**SUBDIVISION COMMITTEE
METROPOLITAN AREA PLANNING COMMISSION**

**STAFF REPORT
(Preliminary Plat)**

CASE NUMBER: S/D 90-49 - TRINKLE ADDITION

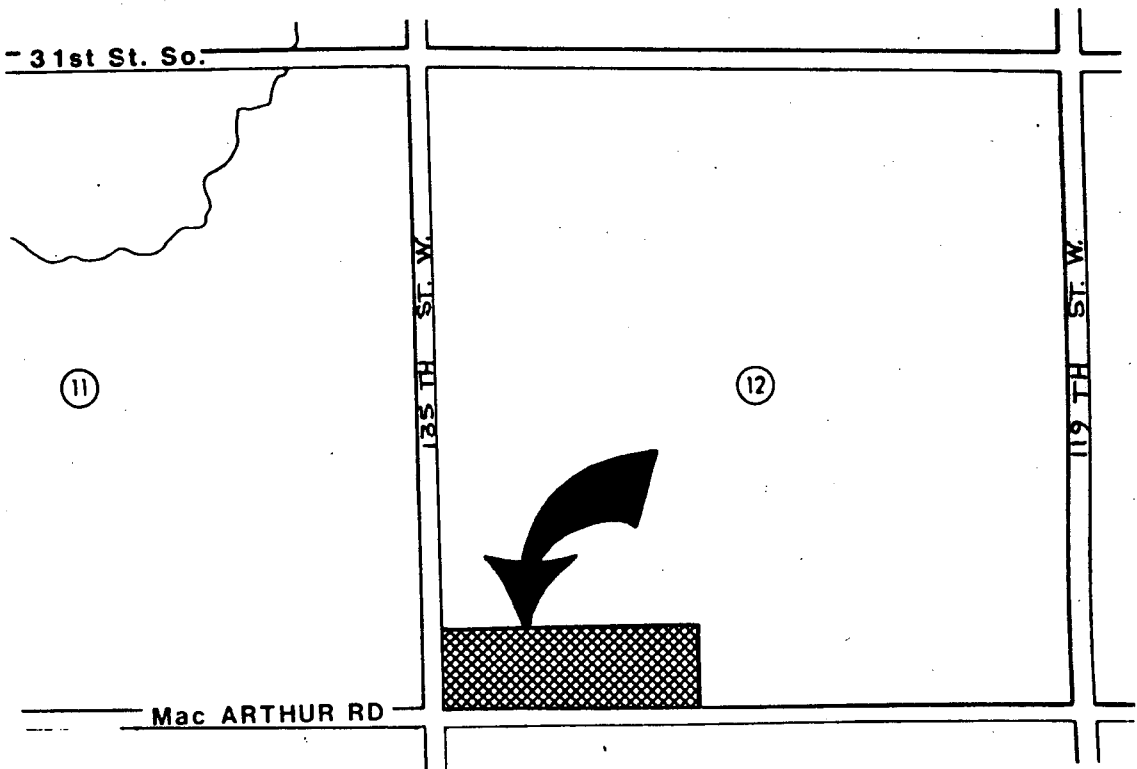
- A. Since neither municipal water nor sanitary sewer is available to serve this property, the applicant shall contact the Environmental Health Division of the Health Department to find out what tests may be necessary and what standards are to be met for approval of on-site sewerage facilities and water wells. A memorandum shall be obtained specifying approval. It should be noted that 3 of the 4 lots, as platted and exclusive of right-of-way, are apparently under 5 acres. Lot 3 is approximately 4.9 acres with Lots 1 and 2 both approximately 4.8 acres.

- B. The applicant shall guarantee any drainage improvements required by the platting of this property.
 - C. If improvements are guaranteed by petition, a notarized certificate listing the petitions shall be submitted to the Planning Department for recording.

- D. If indicated by the drainage plan for this site, a floodway shall be platted, with the standard floodway language referenced in the platting's text. Also, if required, minimum building pad elevations shall be indicated.

- E. The final plat shall indicate the platting of access control to the adjacent highways. No lot shall be provided more than two openings to any one highway, with 100-feet of complete access control indicated along Lot 1 at the intersection of 135th St. West and MacArthur Road.

- F. The final plat shall indicate 25-foot building setbacks to the adjacent highways.
 - G. On the final plat the center lines of 135th St. W. and MacArthur Road shall be labeled.

- H. The final plat tracing shall indicate angles or bearings for the perimeter of this plat.
 - I. As indicated in the title binder, a K.G.&E. easement, granted by separate instruments, is indicated over a portion of this site. A copy of this instrument shall be submitted with the final plat.

- J. Prior to or at the time of submitting the final plat, the applicant shall submit a drainage plan to County Engineering for review and approval.

- N. The representative from County Engineering should be prepared to comment on the status of the applicant's drainage concept. Engineering also needs to indicate if a floodway and minimum building pad elevations are required for this site. If a floodway is required, Engineering should further indicate if any agreements should be required concerning the ownership and maintenance of the floodway. Finally, Engineering also needs to indicate if a public street should or can be provided across this site northward from MacArthur or in the area along the west line of Lot 4. Ownerships in this quarter section have created some awkward land patterns for potential development and another area may become land locked.

CASE NUMBER: S/D 90-49 - TRINKLE ADDITION

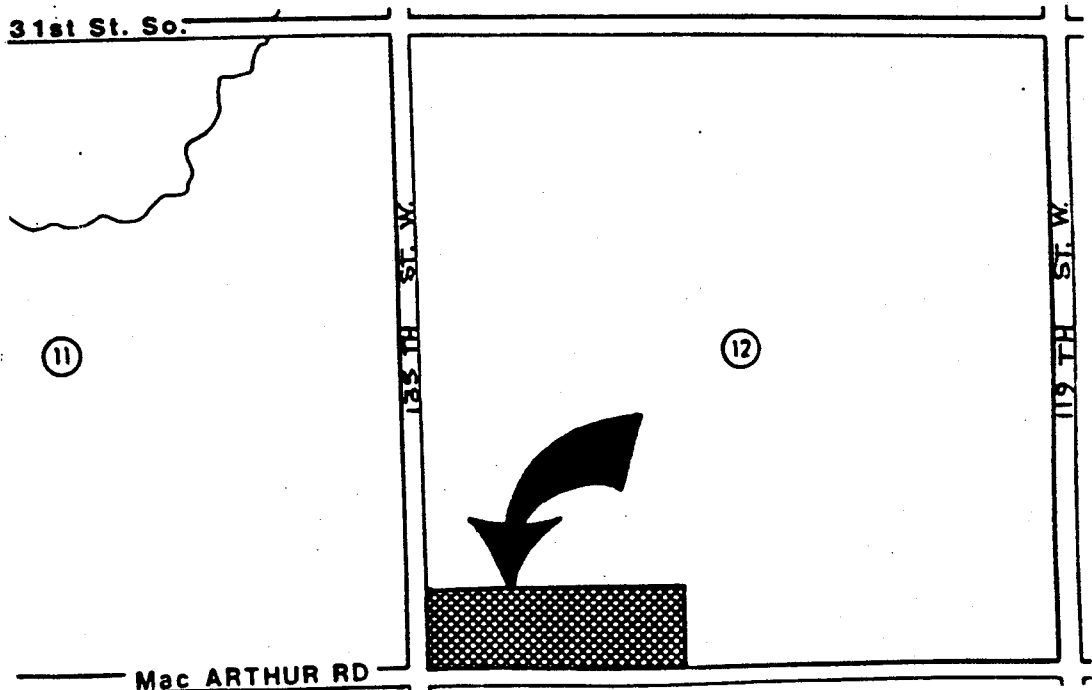
NOTE: A final plat for this site, involving four (4) lots was approved by the Subdivision Committee on October 4, 1990 and by the Metropolitan Area Planning Commission (MAPC) on October 11, 1990. A conditional use (CU-337) to allow up to two manufactured homes on this site was also approved by the MAPC and County Commission. The preliminary plat first submitted for the site was for two (2) lots but was changed to a final with four (4) lots based in part on the applicant's understanding that the County Commission's approval of the conditional use only restricted the overall site to two manufactured homes with therefore conventional homes being allowed on any other lots that could be platted out of the overall site.

However, Health Department approval apparently could not be obtained, because of site limitations, for a four (4) lot plat. Consequently, the applicant is again revising the final plat to a two (2) lot plat.

A. Since neither municipal water nor sanitary sewer is available to serve this property, the applicant has contacted the Environmental Health Division of the Health Department to find out what tests may be necessary and what standards are to be met for approval of on-site sewerage facilities and water wells. A July 24, 1991 memorandum from Environmental Health has been provided which apparently indicates that on-site sewer and water has been approved, subject to conditions, for a two (2) - lot plat at this site. The representative from the Health Department needs to verify that this approval is applicable to the plat now being reviewed.

B. The applicant shall submit with the final plat, for recording, a covenant concerning ownership and maintenance of the floodway. This covenant shall indicate that if necessary, the County may enter this floodway in order to maintain it and charge back any costs against the involved properties in a manner similar to special assessments.

C. The platting or title binder previously submitted for this plat is dated July 24, 1990. That binder is no longer acceptable and a new or amended binder shall be submitted with the final plat tracing.

- F. Perimeter closure computations shall be submitted with the final plat tracing. Section 5-10(c).
- G. Recording of the plat within 30 days after approval by the City Council.
- H. The representative from the County Engineer's office should be prepared to comment on the status of the applicant's drainage plan. Specifically, are the minimum building pads correct and are the boundaries of the floodway adequate.

The applicant has submitted a draft of this covenant. Our review of this draft indicates that it is acceptable and a signed copy shall be submitted, with the final plat tracing, for recording.

CASE NUMBER: S/D 90-49 - TRINKLE ADDITION

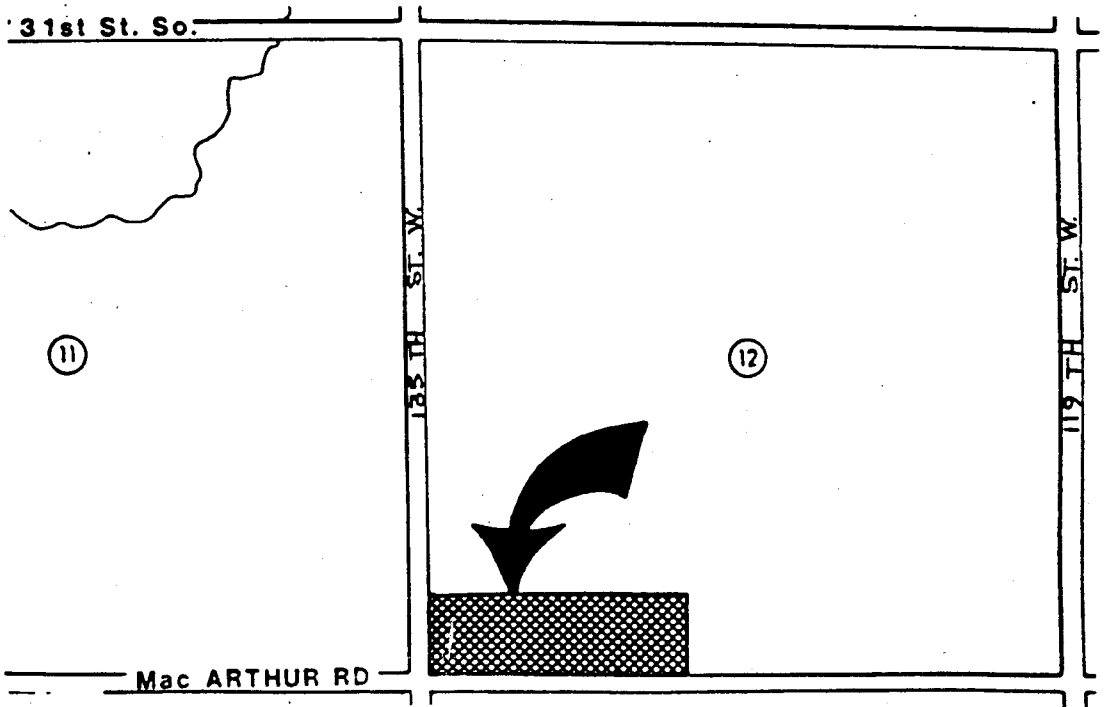
- NOTE: This final plat was deferred from the Subdivision Committee's September 20, 1990 meeting. The final plat submitted at that time was platting two lots rather than the four originally indicated on the preliminary plat. Based upon actions of the County Commission concerning a conditional use request for this site (for manufactured housing), the applicant is again requesting the platting of four lots.

- A. Since neither municipal water nor sanitary sewer is available to serve this property, the applicant shall contact the Environmental Health Division of the Health Department to find out what tests may be necessary and what standards are to be met for approval of on-site sewerage facilities and water wells. A memorandum shall be obtained specifying approval.

- D. The applicant shall submit with the final plat, for recording, a covenant concerning ownership and maintenance of the floodway. This covenant shall indicate that if necessary, the County may enter this floodway in order to maintain it and charge back any costs against the involved properties in a manner similar to special assessments.

- E. On the final plat tracing the plattor's text shall be amended to note the granting of utility easements and to also indicate the complete access control (C.A.C.) dedicated at the intersection of 135th and MacArthur. Also, since 4-lots instead to two are now being platted, the plattor's text shall also be amended to indicate the access controls for these four lots. The text on this final plat still only reflects a 2-lot plat.

- I. Perimeter closure computations shall be submitted with the final plat tracing. Section 5-101(c).
- J. Recording of the plat within 30 days after approval by the City Council.
- K. The representative from County Engineering should be prepared to comment on the status of the applicant's drainage plan. Also, Engineering needs to indicate if minimum building pad elevations are required and if the boundaries of the floodway are adequate.

CASE NUMBER: S/D 90-49 - TRINKLE ADDITION

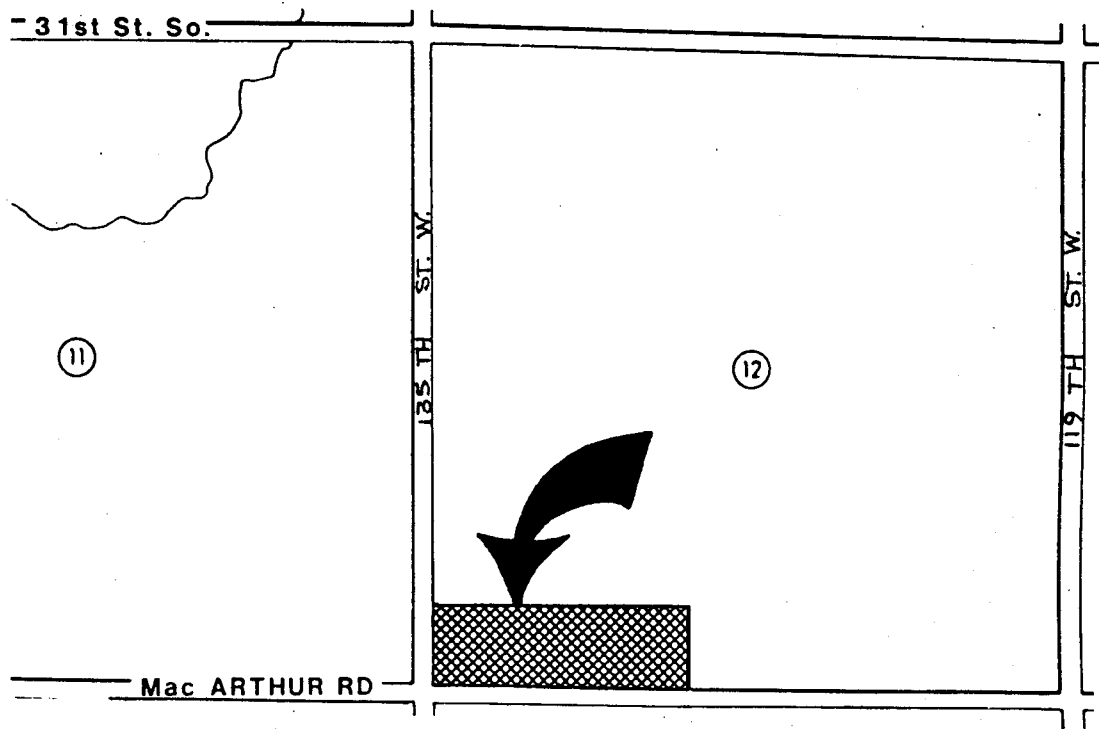
- NOTE: The applicant has revised this plat to include 2-lots, rather than the 4-lots originally shown. A revised preliminary plat has also been provided. A conditional use (CU-337) request has been filed for this site. The applicant is requesting that this property be approved for use of manufactured housing. The case was scheduled to be heard by the County Commission at its September 12, 1990 meeting.

- A. Since neither municipal water nor sanitary sewer is available to serve this property, the applicant shall contact the Environmental Health Division of the Health Department to find out what tests may be necessary and what standards are to be met for approval of on-site sewerage facilities and water wells. A memorandum shall be obtained specifying approval.

- D. The applicant shall submit with the final plat, for recording, a covenant concerning ownership and maintenance of the floodway. This covenant shall indicate that if necessary, the County may enter this floodway in order to maintain it and charge back any costs against the involved properties in a manner similar to special assessments.

- E. On the final plat tracing the plattor's text shall be amended to note the granting of utility easements and to also indicate the complete access control (C.A.C.) dedicated at the intersection of 135th and MacArthur.

- J. Recording of the plat within 30 days after approval by the City Council.
- K. The representative from County Engineering should be prepared to comment on the status of the applicant's drainage plan. Also, Engineering needs to indicate if minimum building pad elevations are required and if the boundaries of the floodway are adequate.
